# INDIANA DEPARTMENT OF TRANSPORTATION

## APPROVED MINUTES

### December 16, 2010 Standards Committee Meeting

RE: Minutes for the December 16, 2010 Standards Committee Meeting

RAILING, TS-1

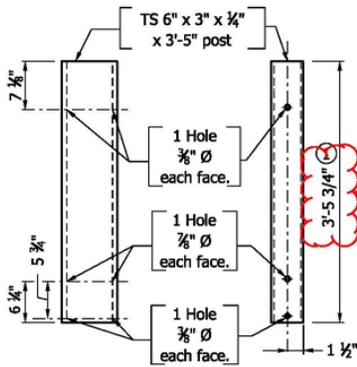
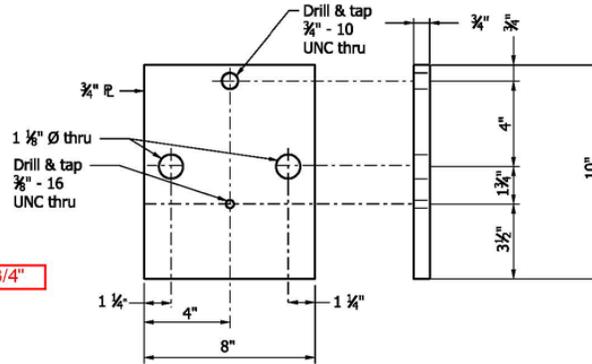
PROPOSED SOLUTION: Revise applicable INDOT Standard Drawings to show the installation height from 27 inches to 27¾ inches to the top of the rail. The proposed change will result into ¾ inch reduced embedment length of the guardrail post which is insignificant and will not impact the strength of the post as the INDOT guardrail posts are 7 feet long compared to 6 feet required for NCHRP 350 TL-3. Also INDOT already has Approved guardrail end treatments that can be used for the 27¾ inches height. The attached drawings are corrected for the changes and the changes are marked on the drawings.

increased by 3/4"

DISCUSSIONS: Presented and explained by Mr. Shah. The corrections and revisions to these drawings were incorporated in accordance with the comments made from the September Standards Committee meeting. Most of the revisions were simply editorial changes to correct dimensions to 27 ¾ inches. (max is 28 inches). This will be for new projects, 100% new construction. Standard drawings will show 27 ¾ in.
